**STAFF RECOMMENDATION**  
**3910 Kimpalong Avenue**  
**October 19, 2016**

**Application:** New construction - infill  
**District:** Woodlawn West Neighborhood Conservation Zoning Overlay  
**Council District:** 23  
**Map and Parcel Number:** 10316007300  
**Applicant:** Vintage South Development  
**Project Lead:** Paul Hoffman, paul.hoffman@nashville.gov

**Description of Project:** An application for new construction of a single-family residence.

Figure 5. Proposed infill roof form

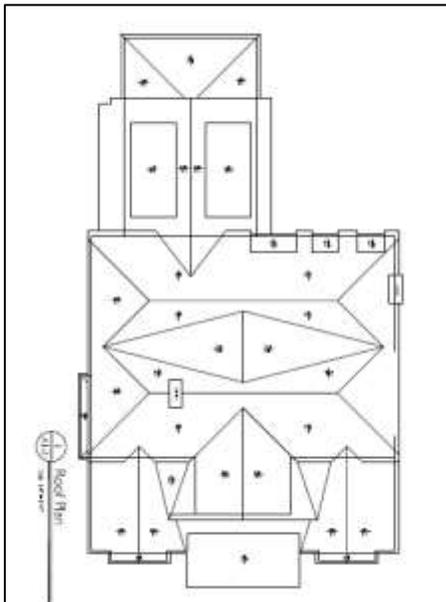
The proposed roof form includes hipped and gabled roofs and shed dormers on the rear attached garage, and a shed roof over the front porch. Individually these roof forms are found in the district. There are examples of a combination of roof shapes individually in this district, but Staff's review is that the overall roof form is unnecessarily complicated

and emphasizes the building's height. Staff finds that the roof form proposed contrasts with the roof forms of nearby structures, and does not meet section II.B.1.e.

1 Site Plan  
A1-0 Scale 1/16" = 1'-0"

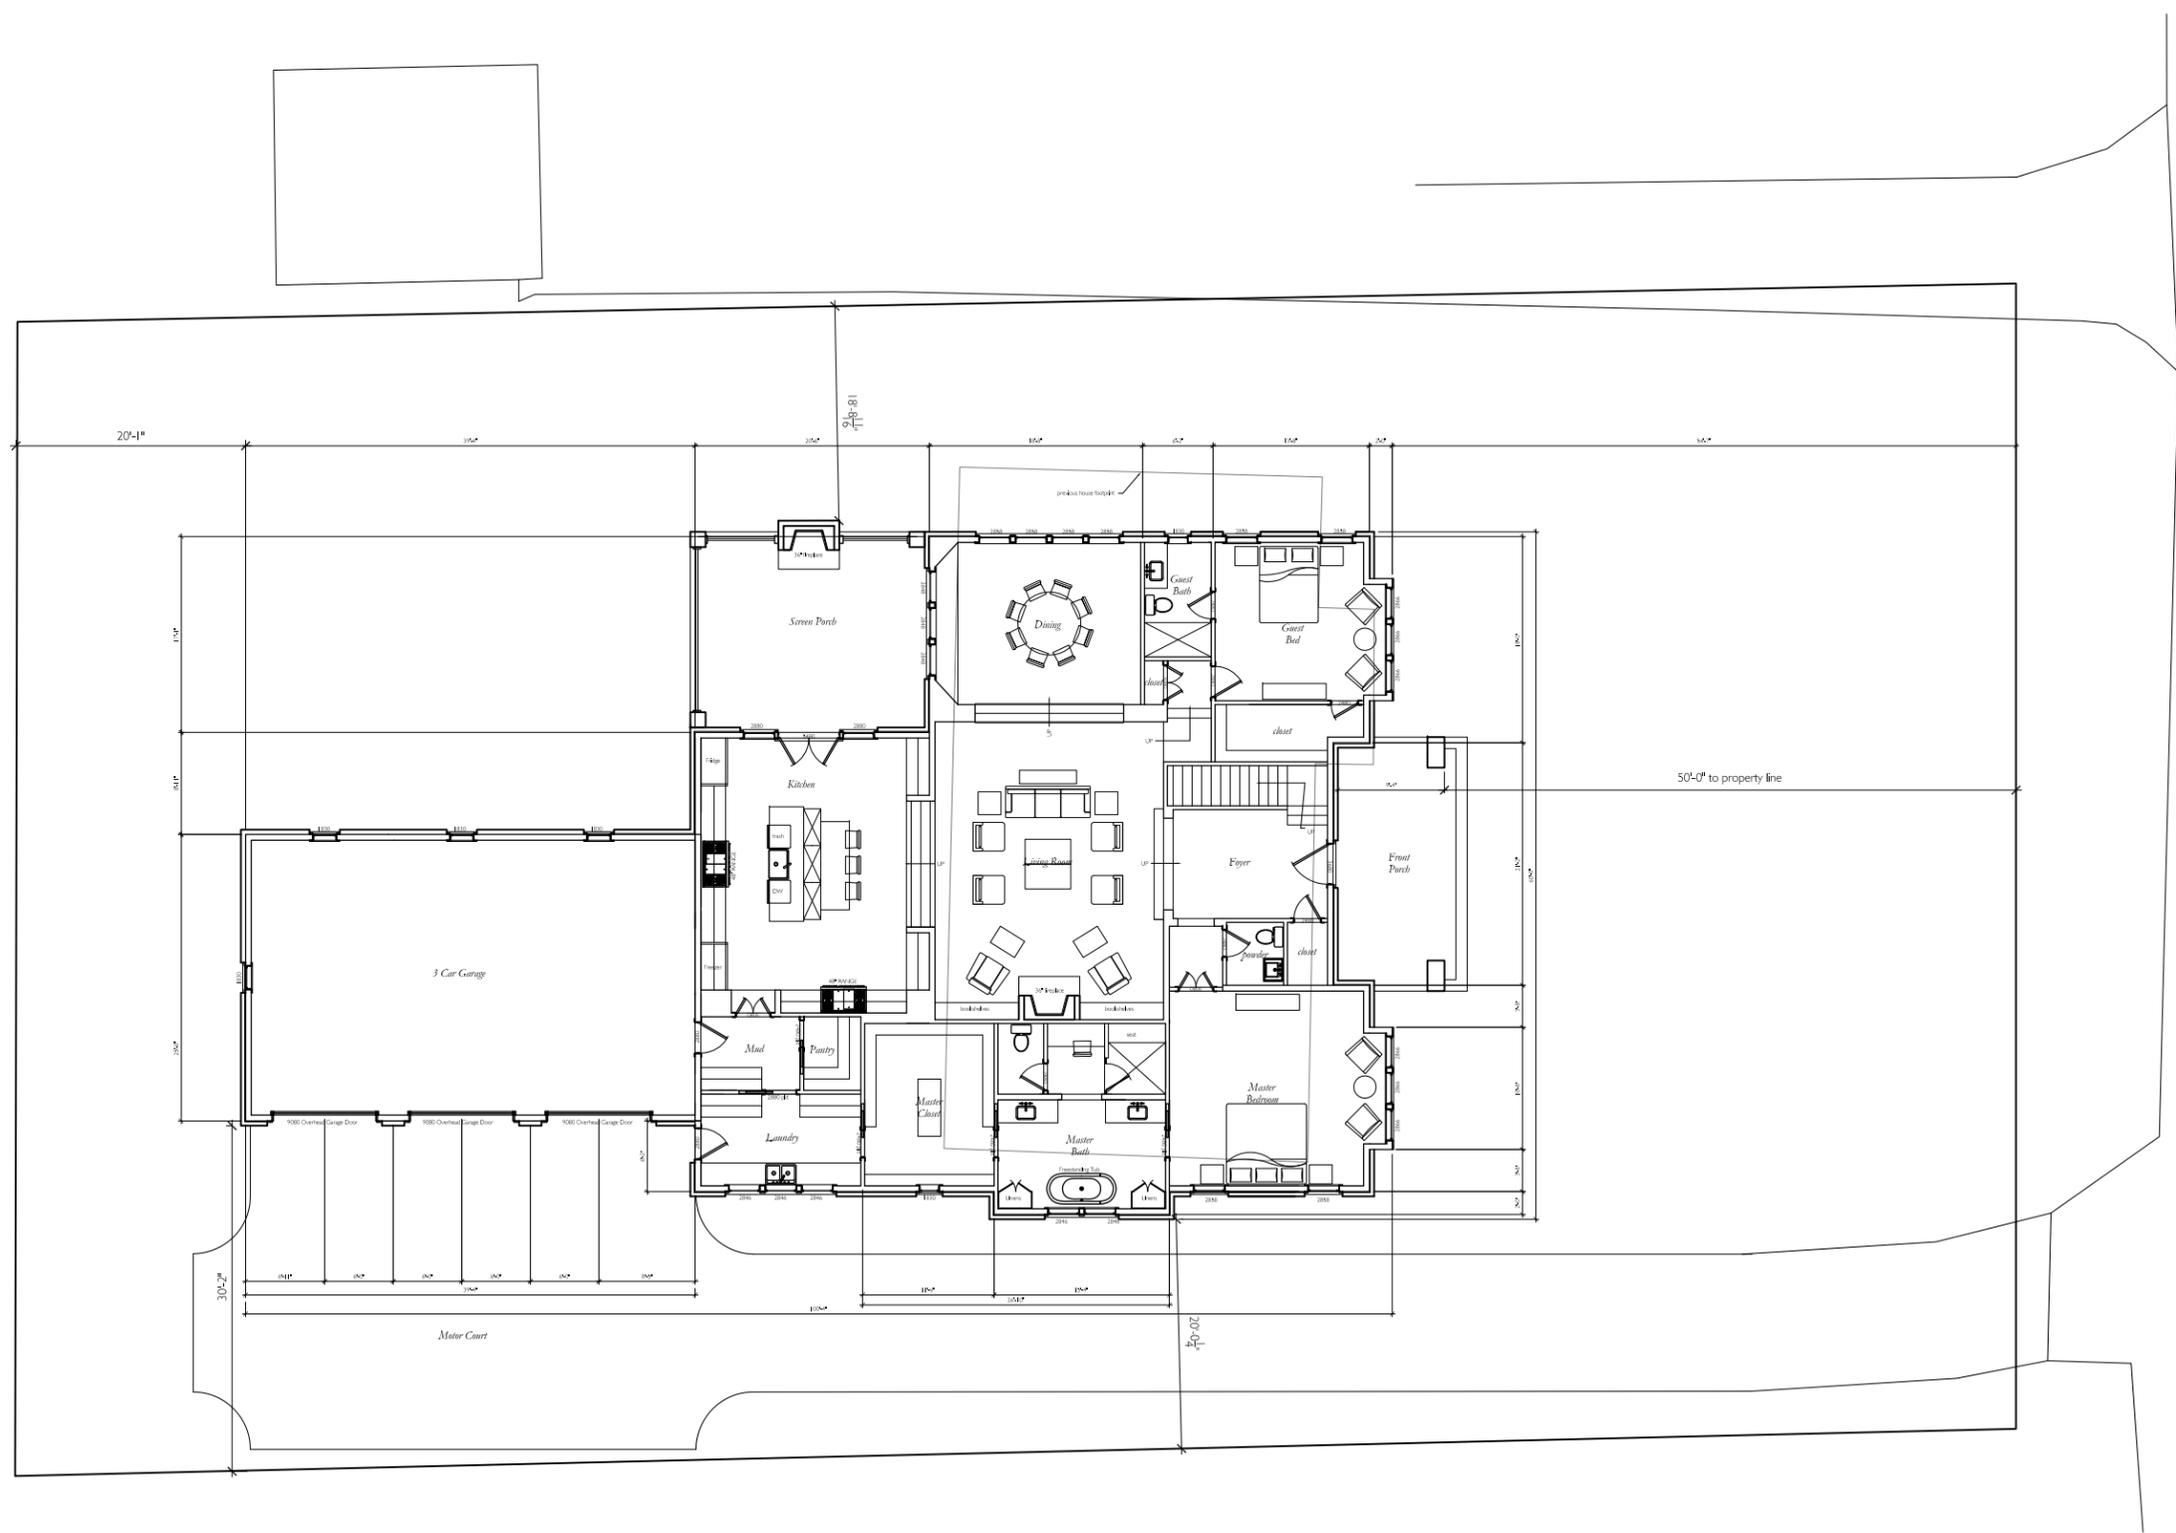
The site plan does not show a walkway to the street, which staff recommends, to meet the majority of the historic context.

**Outbuilding:** Attached outbuildings are normally discouraged. On this street, however, there is no rear alley. There is an existing carport behind the house. In the proposed location, the garage will be minimally-visible. Where attached garages with side entrances have been approved, the Commission has required a ten foot (10’) setback for the door side. As proposed, the setback is six feet and two inches. Staff recommends a full ten foot setback on the left side of the garage.

The project will utilize an existing curb cut and left-side driveway. Staff recommends that the HVAC be located on the rear façade, or on a side façade beyond the midpoint of the house, to meet section II.B.1.i.
